TECHNICAL NOTE

Project: Poultry Farm at Mulsford Farm, Malpas – Outstanding Traffic and Transport Matters

MEMORANDUM

Location: O. S Grid Ref: 428 447 Land at Mulsford Farm, Sarn, Malpas, Wrexham.
Development: Proposed intensive poultry installation and all associated works.

Drawing Number
SK21737-02

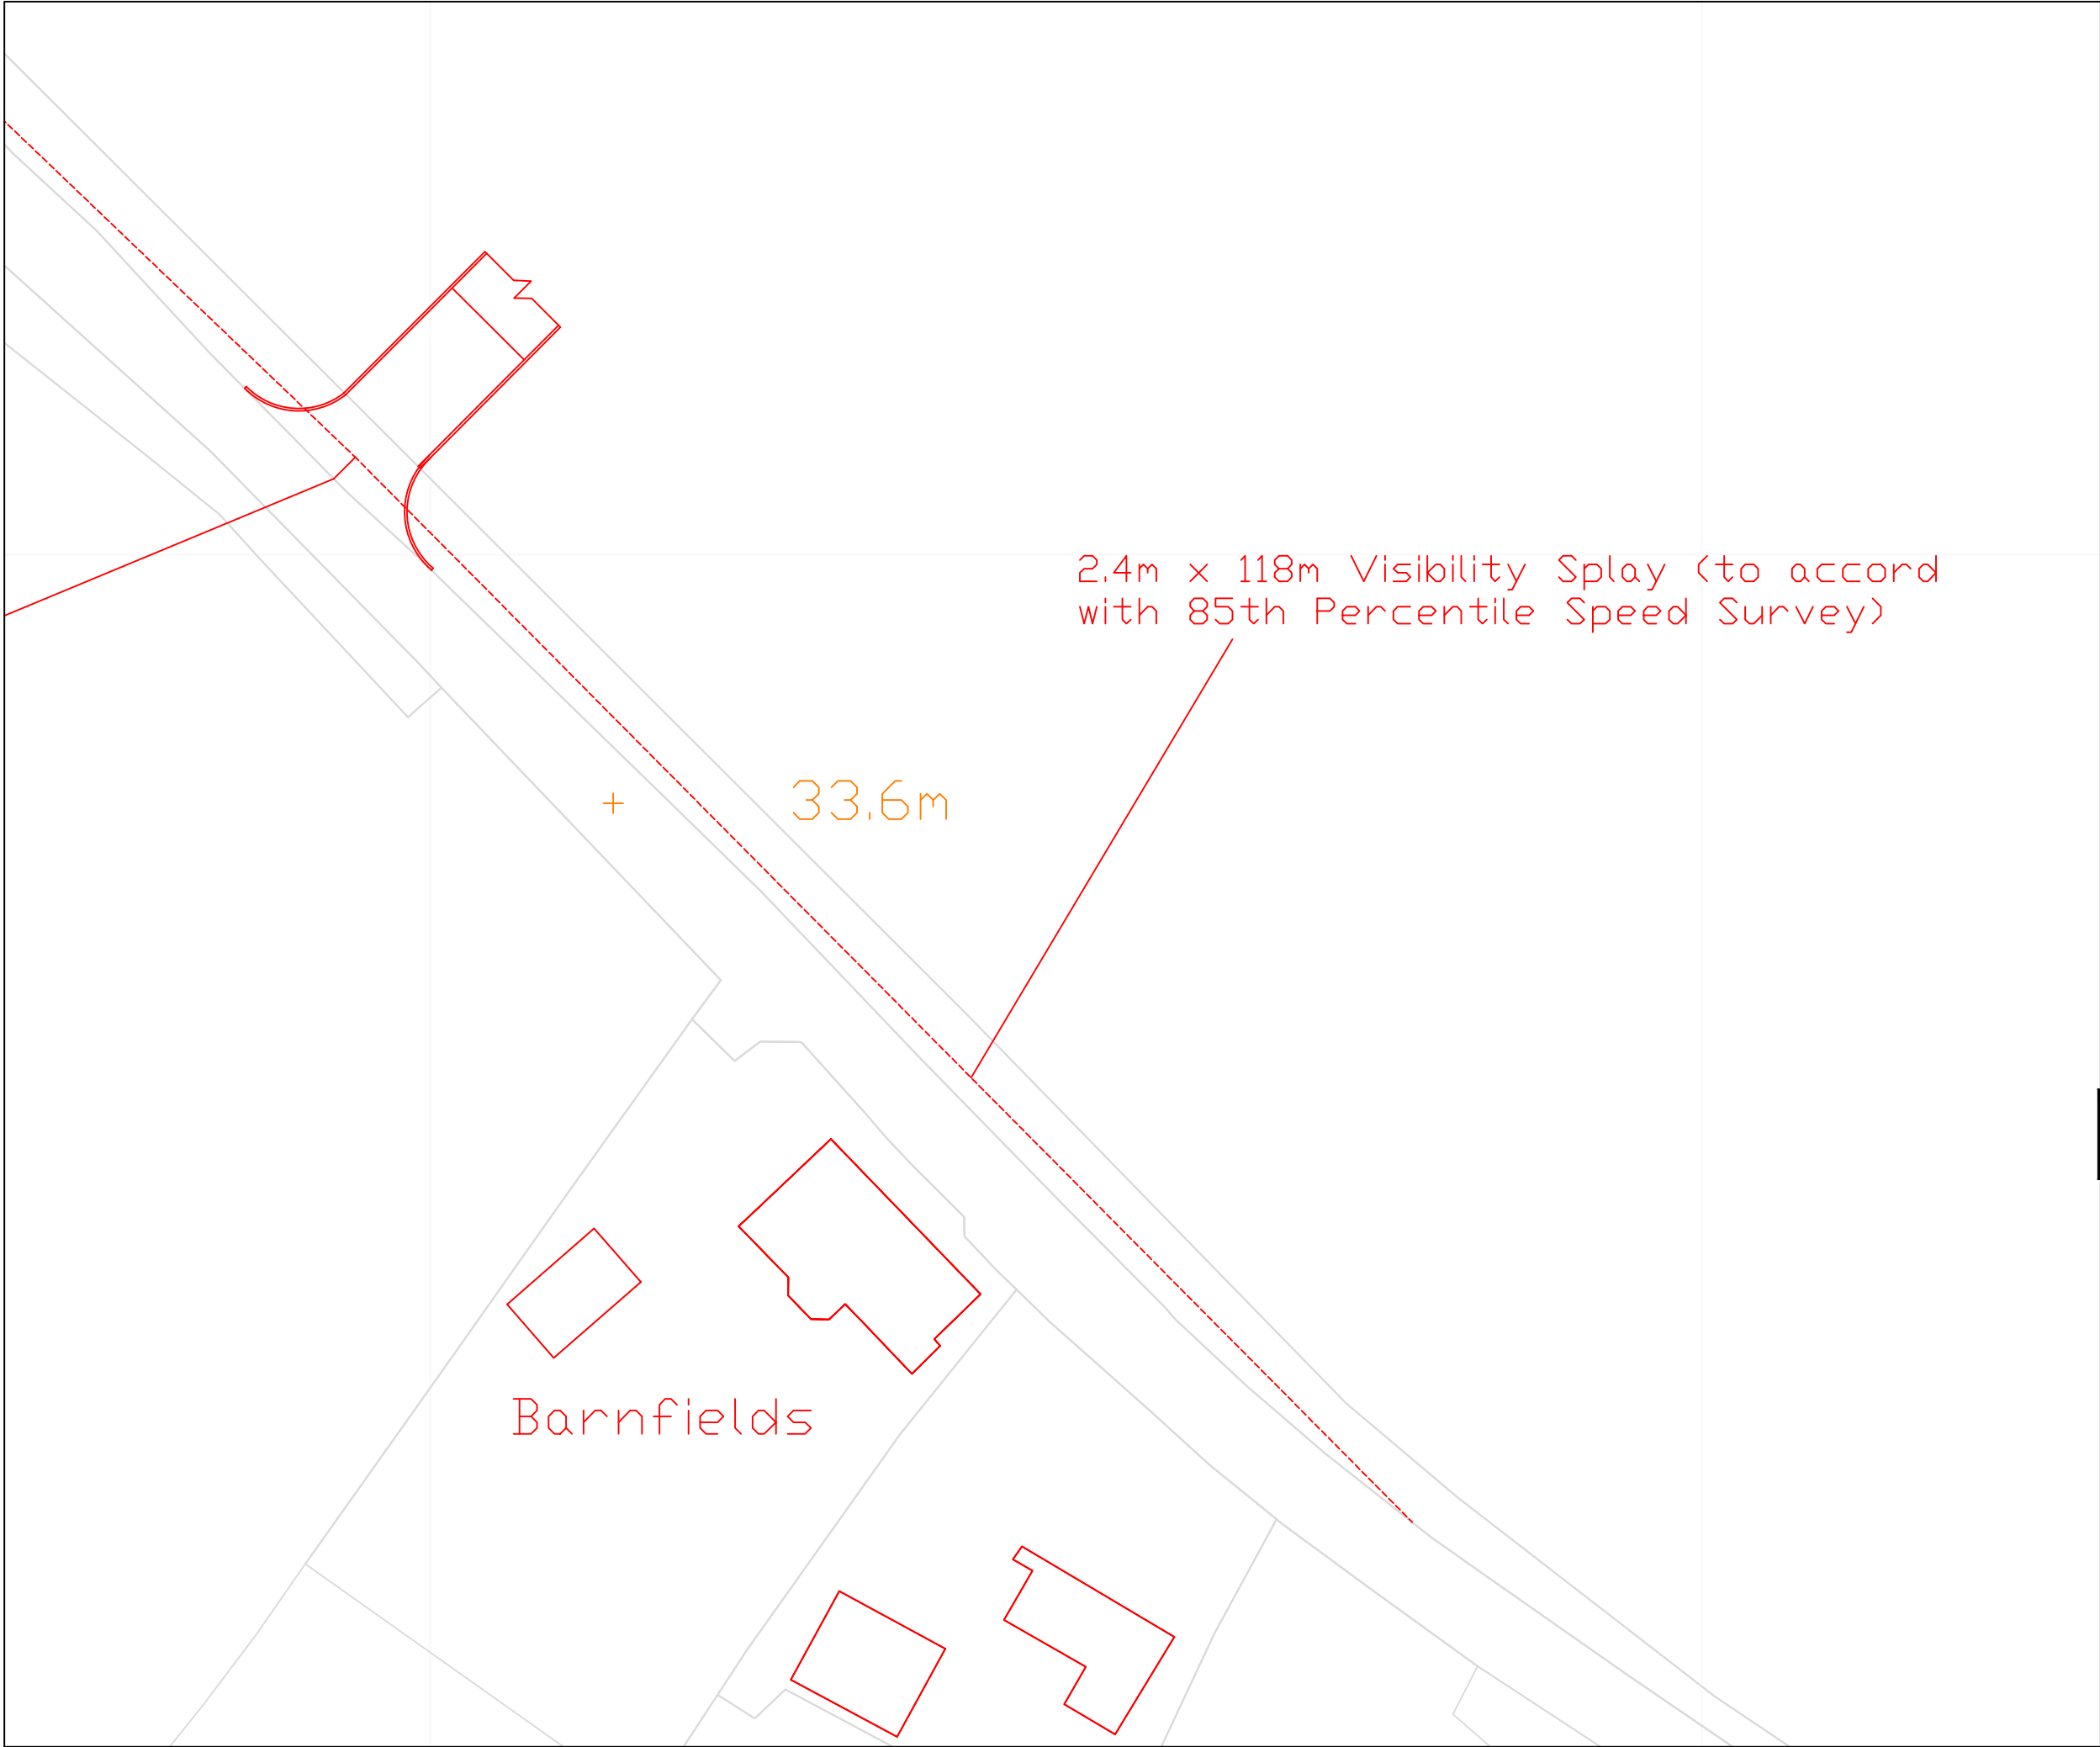
I previously recommended that the applicant considered constructing a new access to serve the development site directly off Queensford located to the east of the Mulsford Lane / Queensford junction. Such an access would be required to provide adequate visibility as detailed above and designed to cater for 16.5m long HGVs. The applicant would be required to enter into a s.278 agreement with the Council in order to construct such an access.

The submitted layout plan (Drg. No. RJC-MZ63-Huxley-01) indicates the construction of a new access directly onto Queensford as suggested. It is proposed to provide visibility splays of 2.4 x 118m in both directions measured to the nearside edge of the adjoining highway in accordance with TAN 18. The provision of the required splay in the north westerly direction would require the setting back of the existing hedgerow on the corner of the Mulsford Lane junction. This land appears to be under the control of the applicant.

If the current application is supported, it would be considered beneficial to utilize any new access onto Queensford to serve this existing business and close up the recently formed access along Mulsford Lane. **I would recommend that this detail is indicated on a revised layout plan.**

- 2.1 The Council has provided a review of the original proposed access arrangements via Mulsford Lane, and the updated access arrangements presented in **appendix b**. The Council has raised concerns with the Mulsford Lane access arrangement, but support the revised proposed access, subject to the provision of 2.4m x 118m visibility splays in both the leading and trailing traffic directions. These splays can be provided on land either controlled by the applicant or the public highway. Whilst there would be a need to relocate the existing hedgerow either side of the site access, this can be delivered as part of the new access arrangements, to be delivered via a S278 agreement.

- 2.2 In discussions with the applicant regarding access to the existing grain store building even with this development generating a very low number of vehicle movements they are prepared to agree to the closure of the existing access onto Mulsford Lane and the new access to be used for the grain store. For information the existing grain store only generates an average of one inbound and one outbound agricultural tractor and trailer movement each day outside of the harvest season, and so the combined use of the proposed new access will be easily accommodated.

SK21737-03

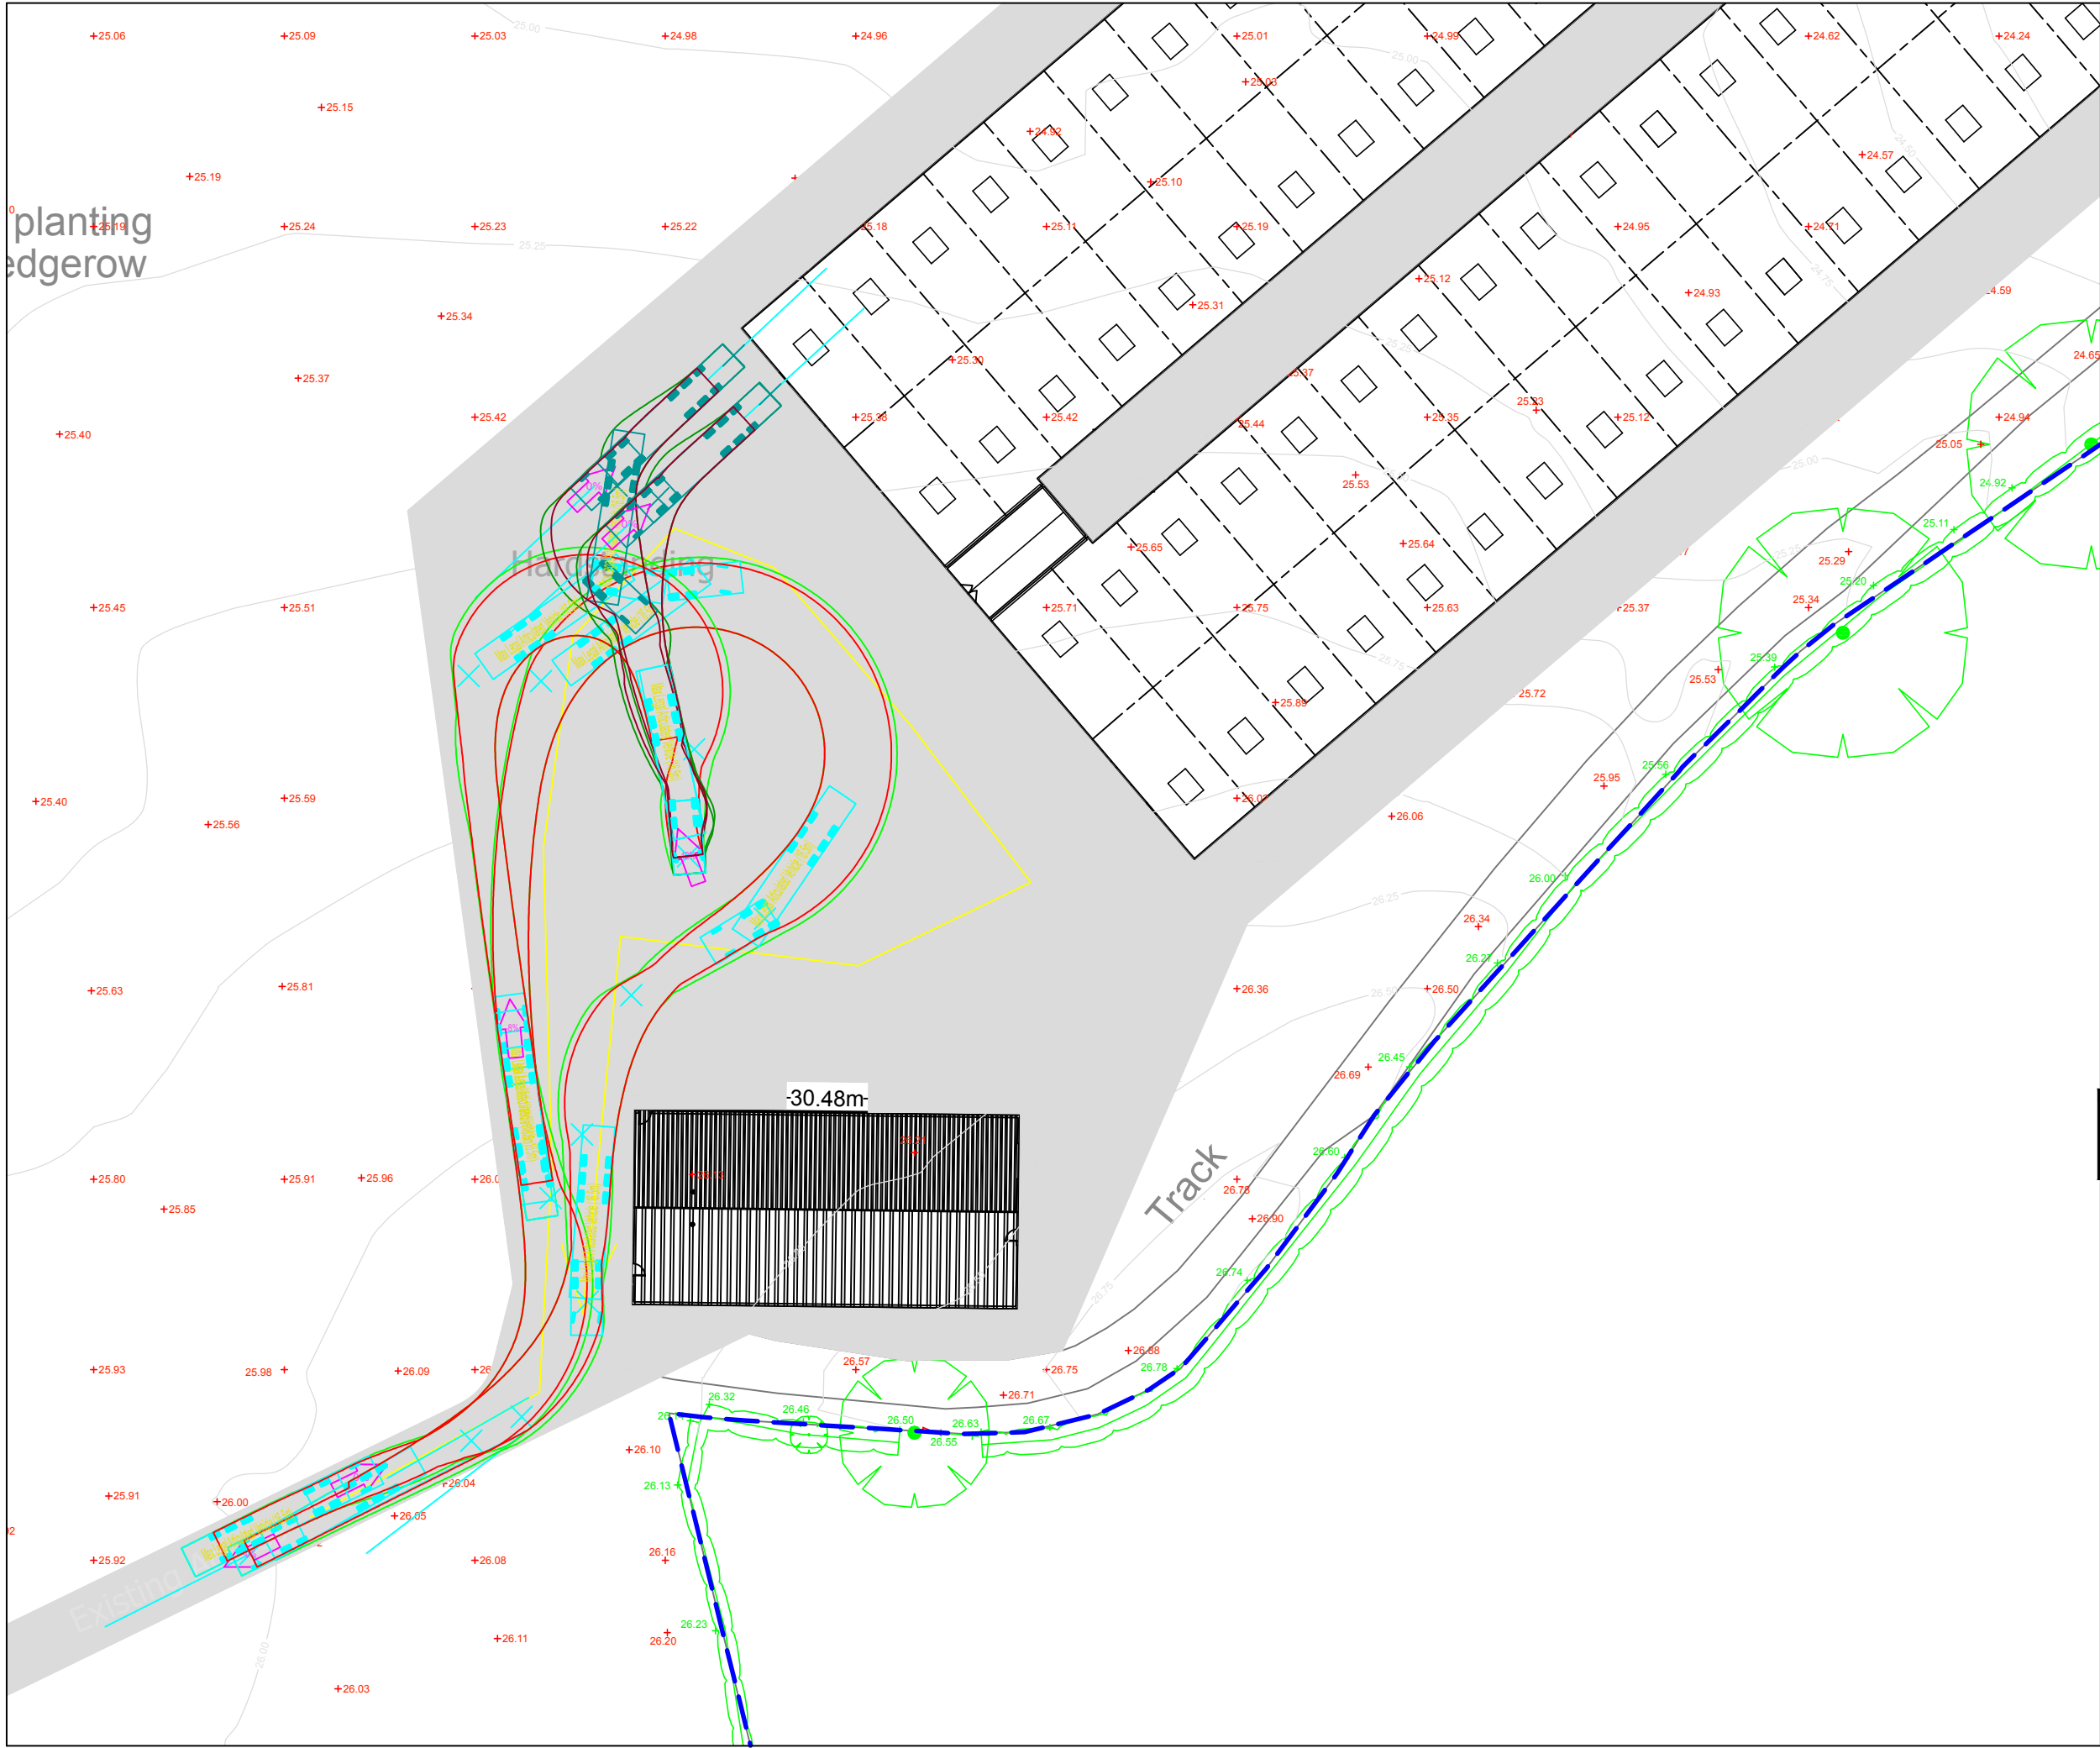
However, I would recommend the submission of a suitable layout plan indicating specific parking and turning arrangements of cars / HGVs within the curtilage of the site. Appropriate swept path details will need to be submitted demonstrating how HGVs (16.5m long) will enter / park / turn / exit the site. Details of maximum number of vehicles likely to be on site at any one time and where they will park shall be provided.

- 3.1 The Council has confirmed that the layout appears to show adequate parking and turning provision on the curtilage of the proposed development. We highlight that the actual parking demand at the site will be very low, with the occasional private car associated with a veterinary visit or site cleaning at the end of the crop cycle.
- 3.2 On the depopulation days HGV's will arrive and depart from the site, with normal practice being no more than two HGV's on the site at any one time (one HGV being loaded with birds, and the second HGV waiting to be loaded). The swept path analysis provided in **appendix c** shows that there is appropriate space for HGV's to load and layover on the curtilage of the proposed development.
